An Environmental Impact Statement (EIS) in support of a State Significant Development Application (SSDA) for the construction and operation of a new multi storey car park at Liverpool Hospital was publicly exhibited for a period of 28 days inclusive between 28 May 2020 and 25 June 2020 (SSD 10388).

This report, prepared by Ethos Urban on behalf of the applicant, sets out the responses to the issues raised and includes design amendments made to SSD 10388 in accordance with Clause 55 of the *Environmental Planning and Assessment Regulation 2000* (EP&A Regulation) for which approval is now sought.

Figure 1 Existing overland flow analysis

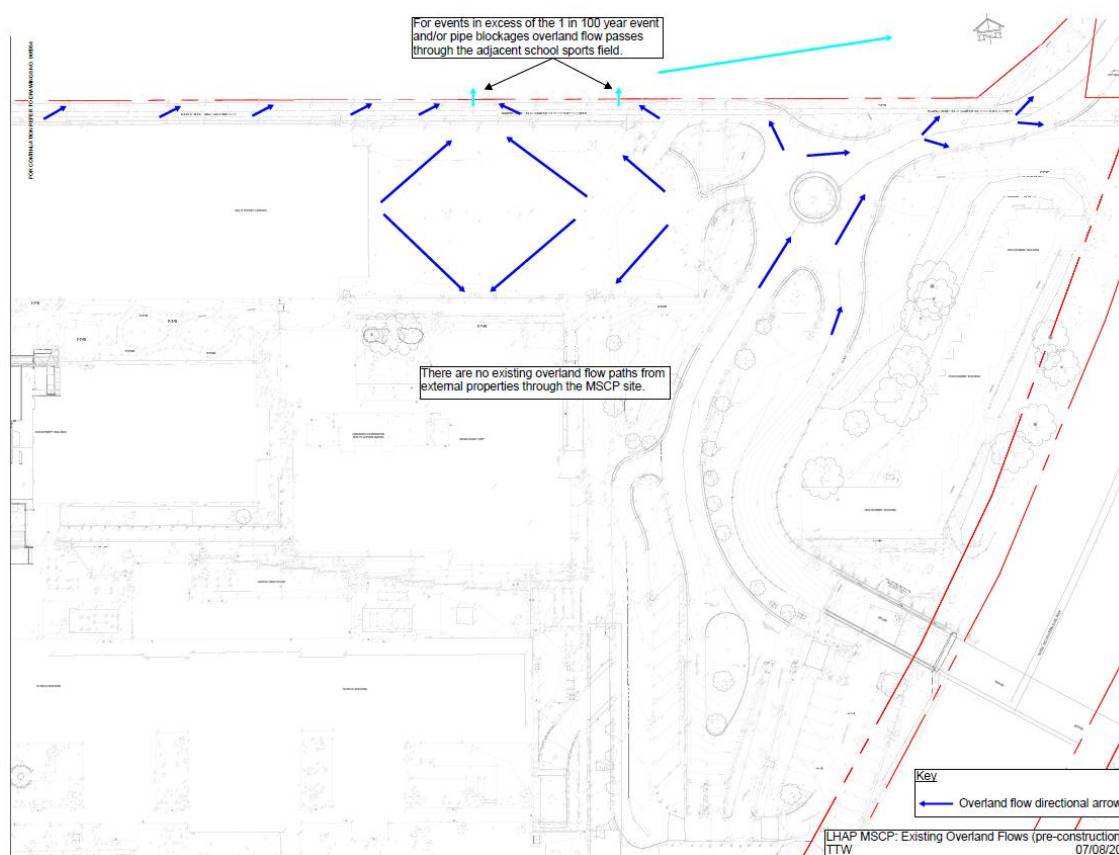
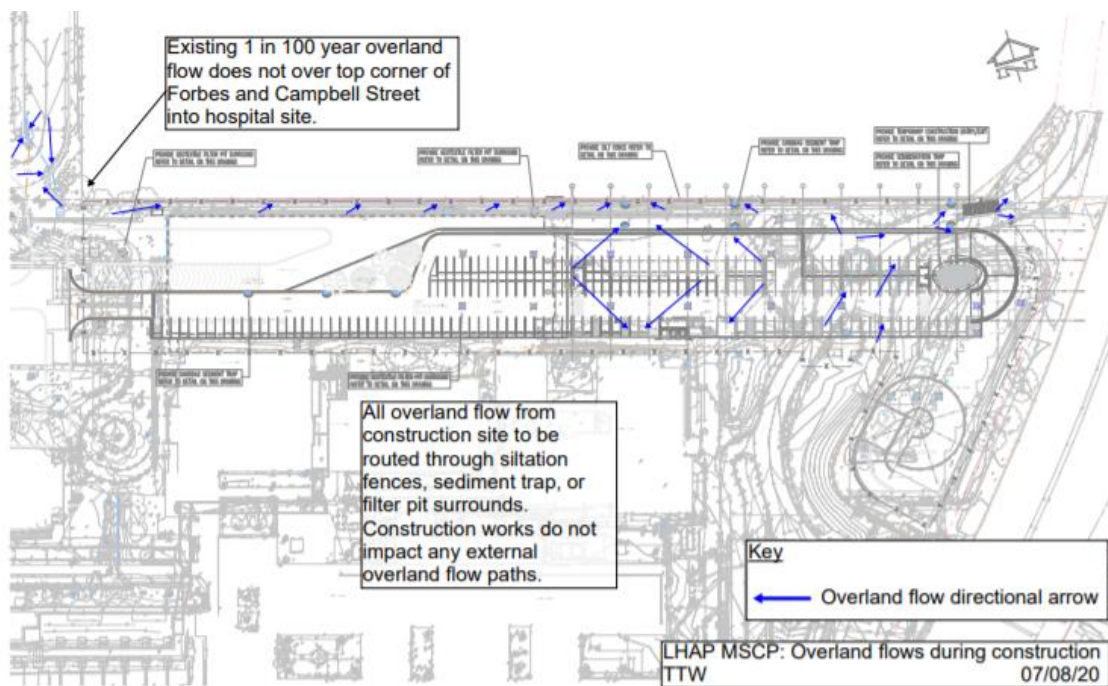
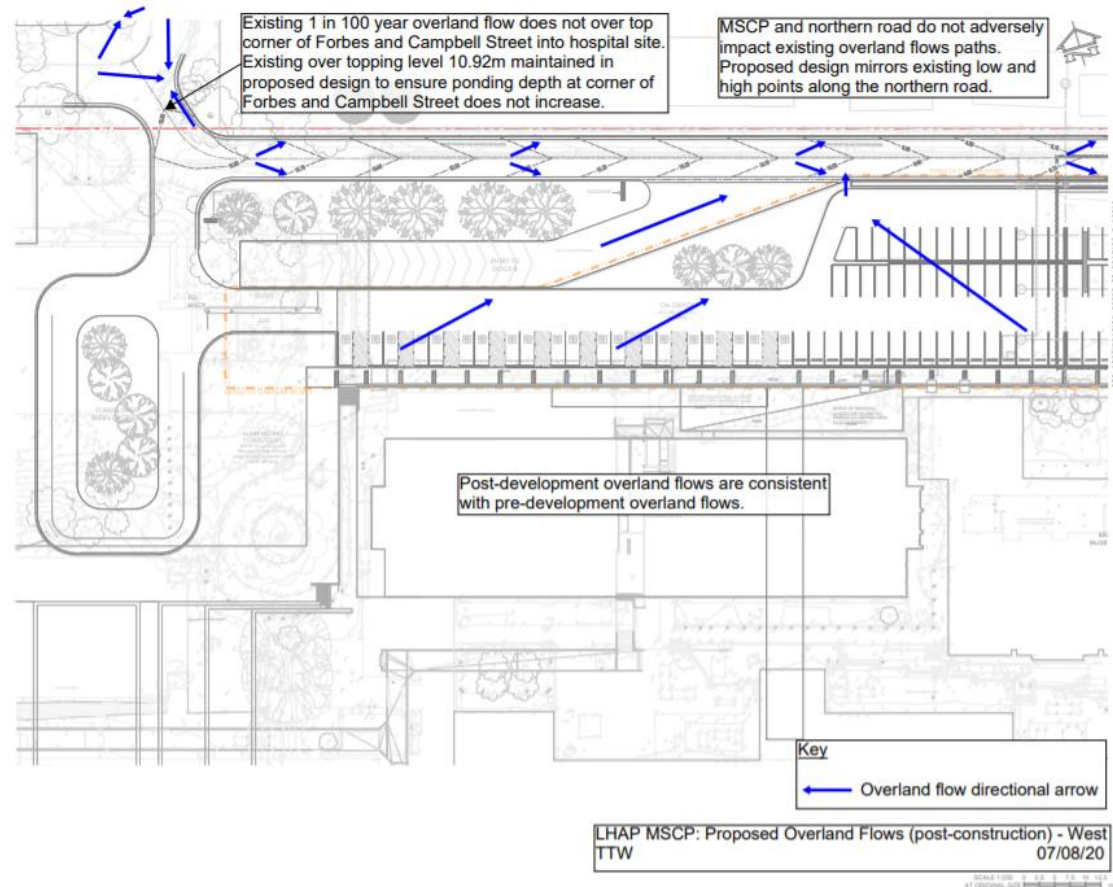
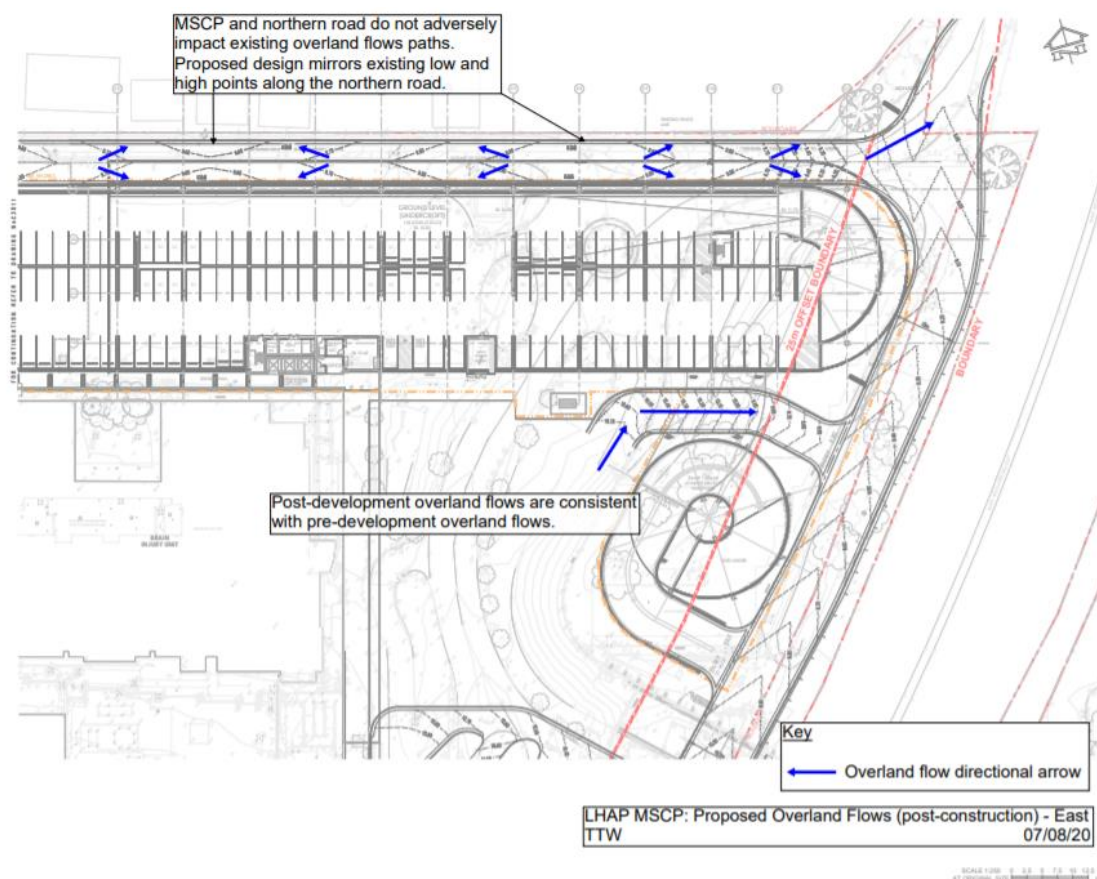
The applicant sought clarification of the DPIE request regarding flooding and DPIE seeks information on how stormwater would be managed during construction and following the completion of construction, given that flows would be altered during the construction of the development and once it is complete.

Plans illustrating the existing, during construction and post construction overland flow directions have been prepared by TTW. The plans illustrate that all overland flow from the construction site will be managed through siltation fences, sediment traps or filter pits. As shown in **Figure 1** to **Figure 4** below, the proposed construction works will not impact any external overland flow paths and during the post development scenario, overland flows are consistent with the pre-development overland flows. The overland flow path analysis is included at **Appendix L**.
